COLORADO DIVISION OF RECLAMATION, MINING AND SAFETY
MINERALS PROGRAM INSPECTION REPORT
PHONE: (303) 866-3567

MINE NAME: Una Pit	MINE/PROSPECTING ID#: M-1980-080	MINERAL: Sand and gravel	COUNTY: Garfield
INSPECTION TYPE: Monitoring	INSPECTOR(S): Dustin M. Czapla	INSP. DATE: November 15, 2011	INSP. TIME: 10:00
OPERATOR: Grand Junction Concrete Pipe Co.	OPERATOR REPRESENTATIVE: Ivan Geer	TYPE OF OPERATION: 112c - Construction Regular Operation

RE: Permit No. M-80-080
Una Pit

PRE-MINING & MINING PLAN
EXHIBIT "C"
REVISION #2 15 NOV 1993
OPERATOR: GRAND JUNCTION PIPE & SUPPLY CO.

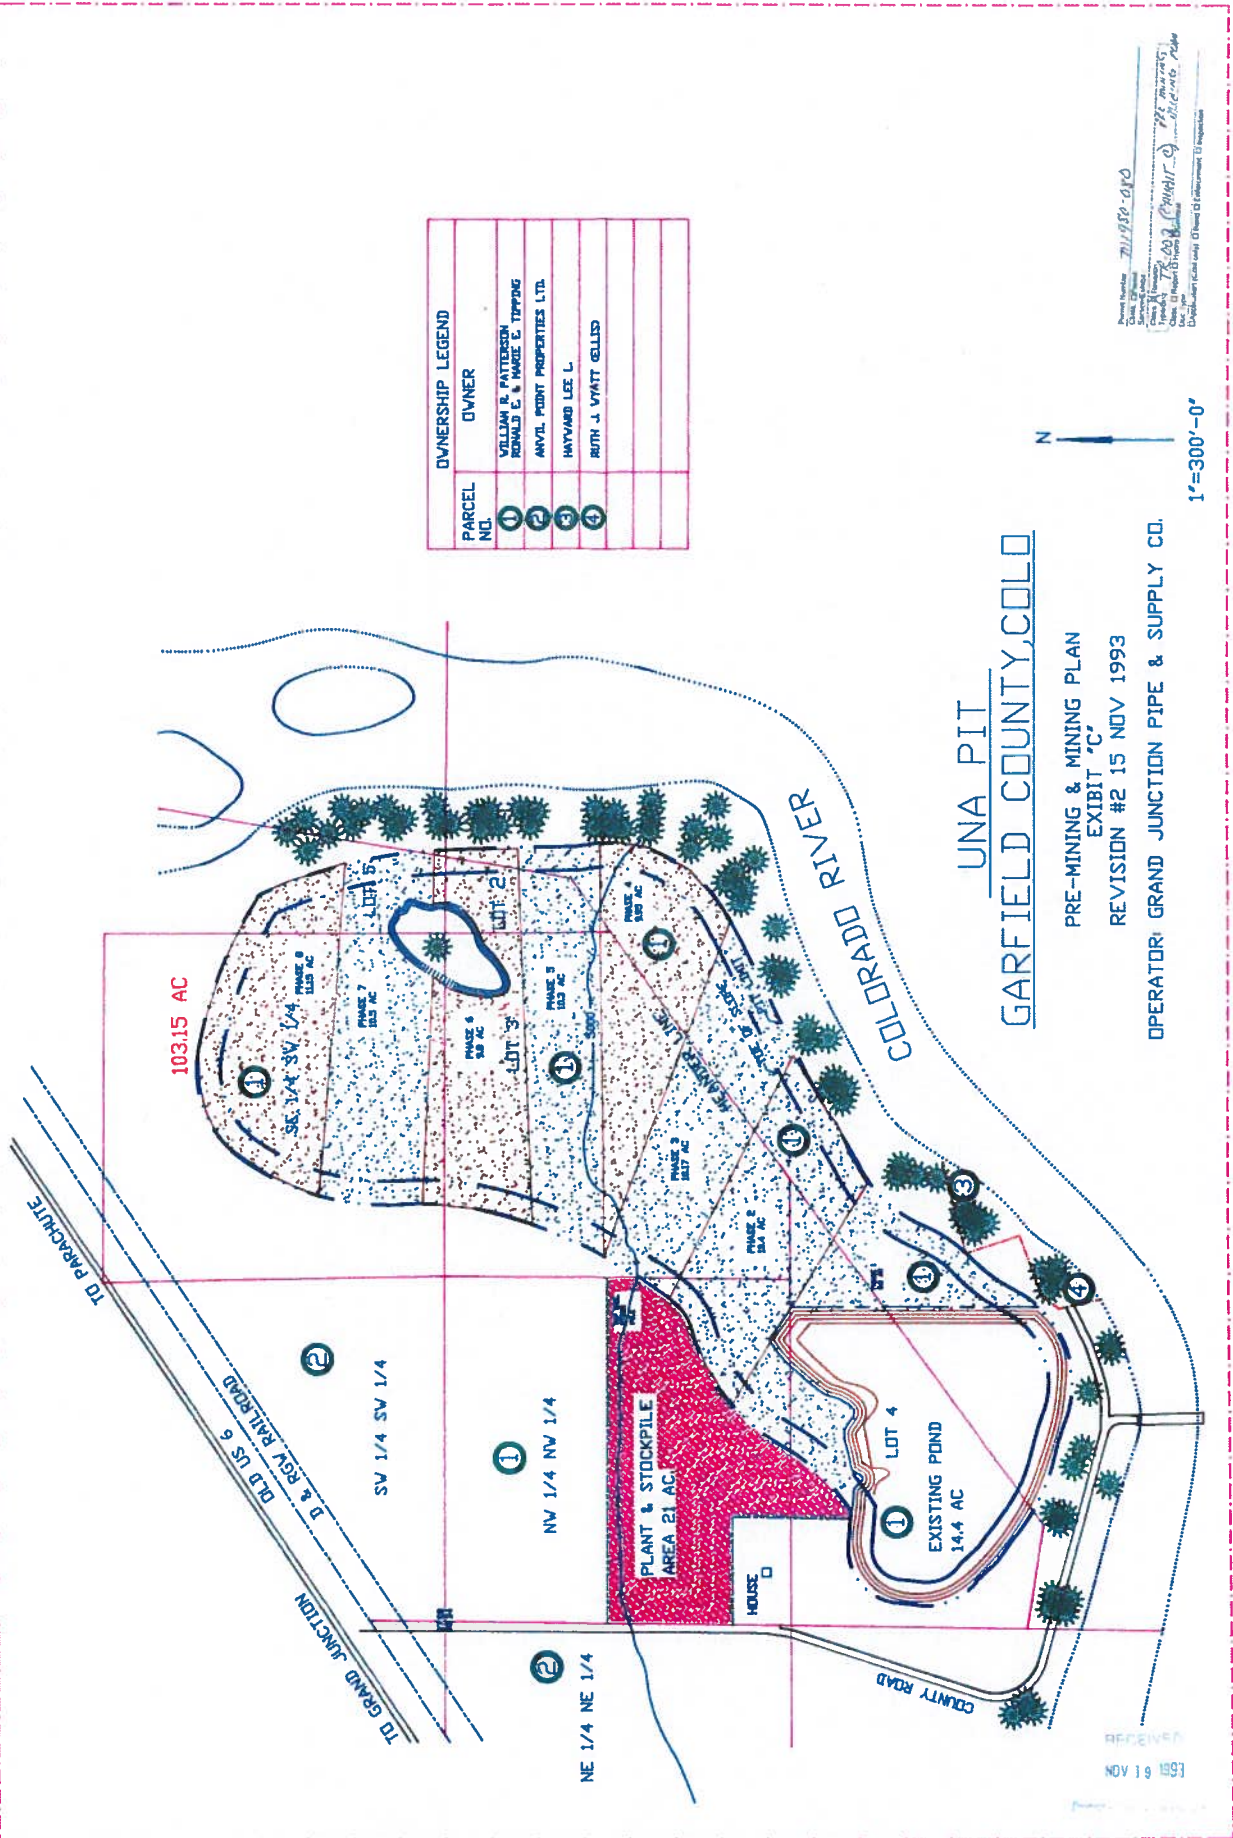
1. Leave the stockpile area in its original location. This will eliminate the need to disturb additional area and reduce the size of the stockpile site by 4 acres when this area is mined. See Revised Exhibit "C".
2. Revise the Mining Plan reducing the size of the area to be mined from 124 acres to 103 acres. The reason for this is to move the mined area closer to the river reducing the amount of overburden to be removed and leaving a larger buffer zone between adjacent properties. See Revised Exhibit "C".

3. Phase the mining operation into 8 phases of approximately 10 acres each. Mining would start adjacent to the existing pond and proceed in a northeasterly direction. A smaller operation would reduce the size of the area disturbed at any given time thus reducing the amount of the reclamation bond required. See Revised Exhibit "C".
4. Reduce the amount of the reclamation bond from \$188,160.00 to \$78,000.00. This amount was determined by calculating reclamation costs to:
